**20022-01-001**

**Proposed Residential Development at  
Railway Street, Portlaoise.**

**ROAD SAFETY AUDIT STAGE 1/2**

**March 2020**

*Photo 1: No Priority Control at Southeast cul-de-sac/hammerhead.*

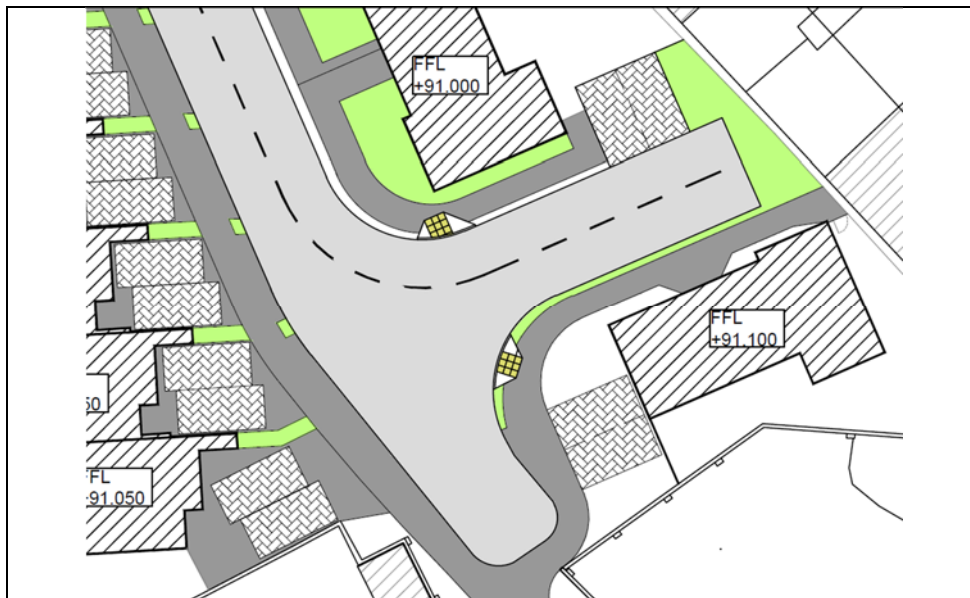
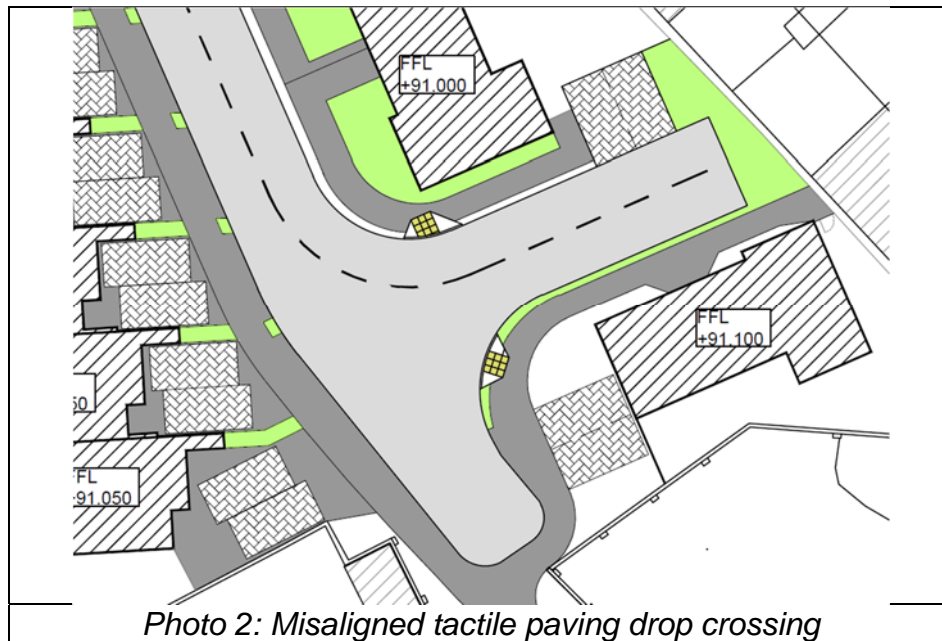
The priority of the southeast cul-de-sac/hammerhead within the development is unclear due to lack of appropriate/adequate road signage and markings. This may lead to driver confusion at the junction as to who has right of way which may contribute to a collision.

Provide yield road markings and signage on the most appropriate arm of this cul-de-sac/hammerhead.

*Photo 3: Main Access Road Low Radius Bends*

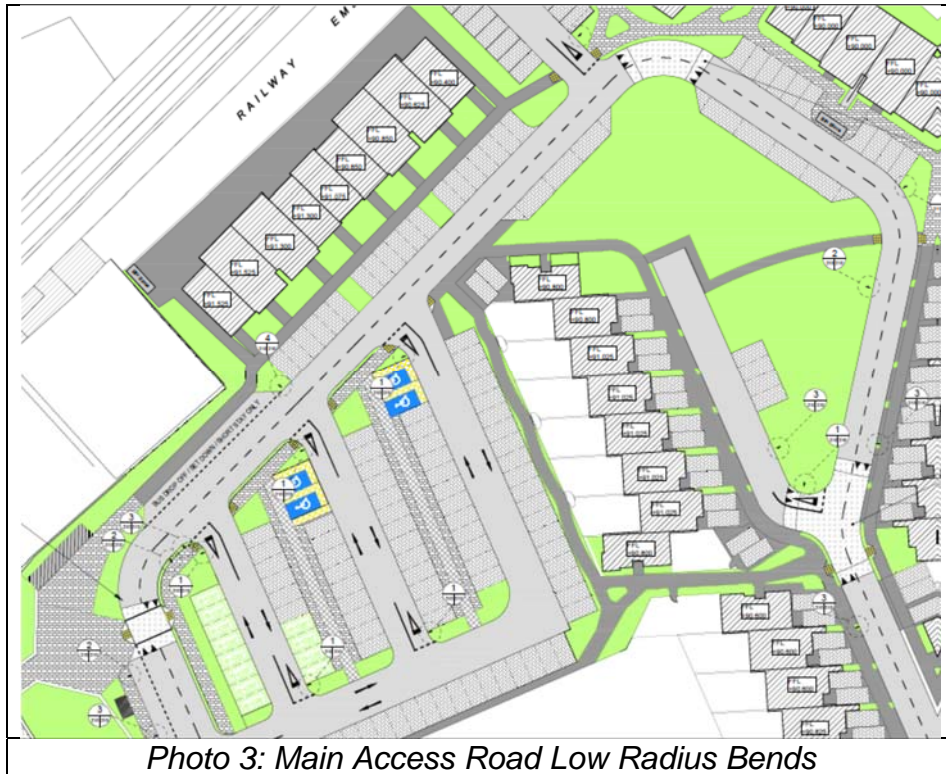
Low radii bends are proposed at a number of locations along the development's main access road. Two vehicles may have difficulty in passing one another on these bends which may lead to a side swipe collision. Stopping sight distance at these bends may also be restricted by vehicles parked in visitor parking bays near the bends which may contribute to a collision.

Revise the layout at the bends to ensure that two vehicles can safely pass one another, and that adequate stopping sight distance is provided throughout.

*Photo 4: Narrow Footpath*

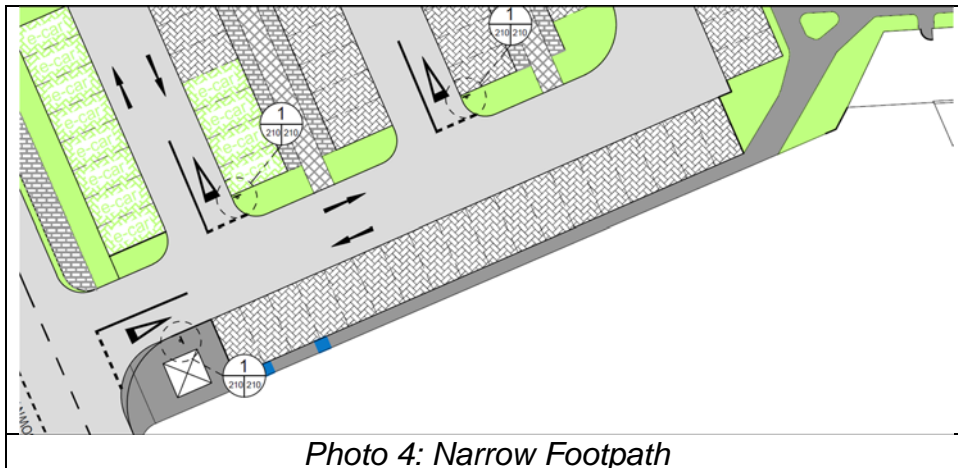
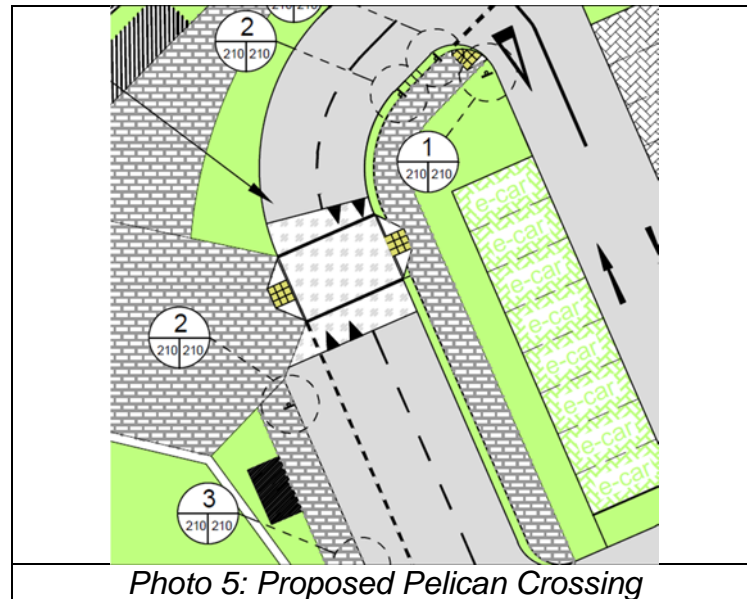
The proposed width of the Main Public Transport Carpark's southern footpath appears to be very narrow and may not cater for mobility impaired pedestrians. As a result, such pedestrians may be forced onto the carriageway or into parking areas where they would be at an increased risk of being struck by a passing vehicle.

Provide adequate footway widths throughout the proposed development.

*Photo 6: Omitted Dropped Crossing & Tactile Paving at Development Access*

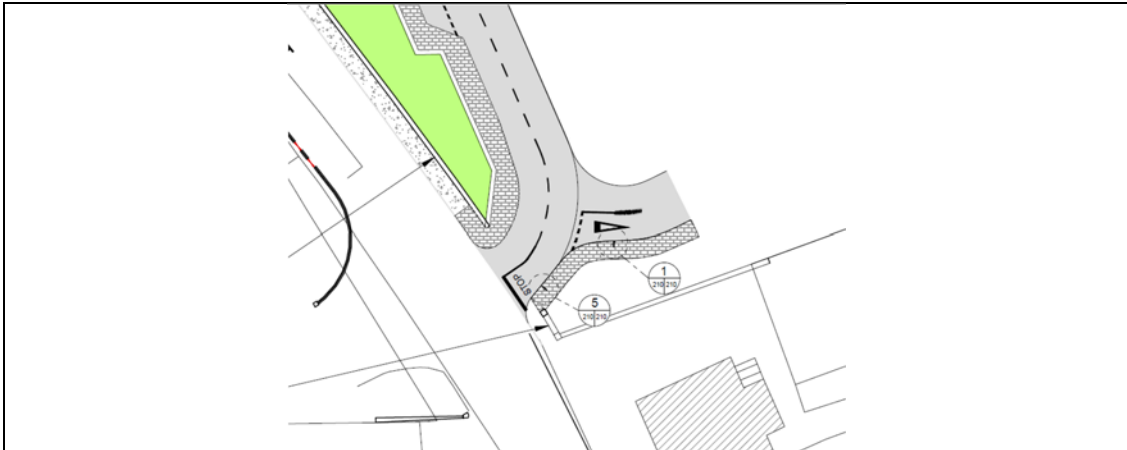
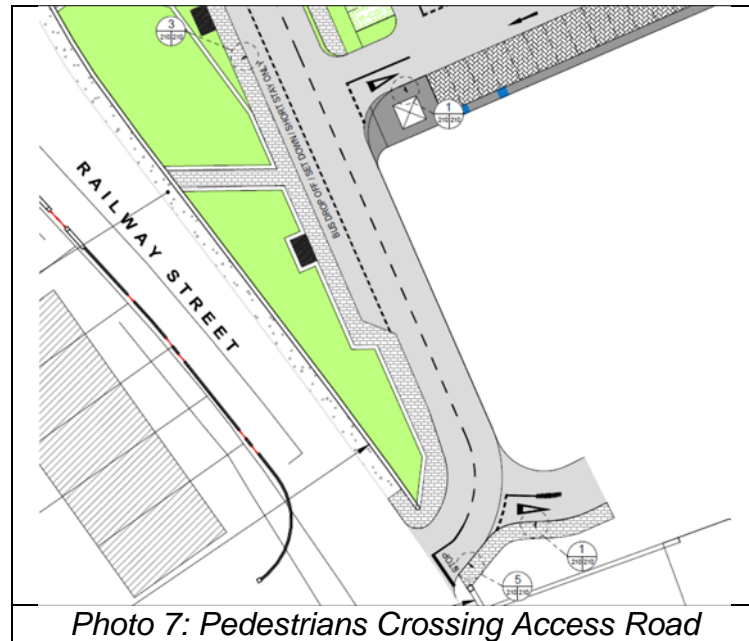
Pedestrian crossing facilities are not shown to be provided for pedestrians across the junction mouth at the access to the proposed development from Railway Station. A lack of adequate pedestrian crossing facilities may contribute to a pedestrian injury at this location.

Provide dropped kerbs and tactile paving at the access to the proposed development from Railway Station.
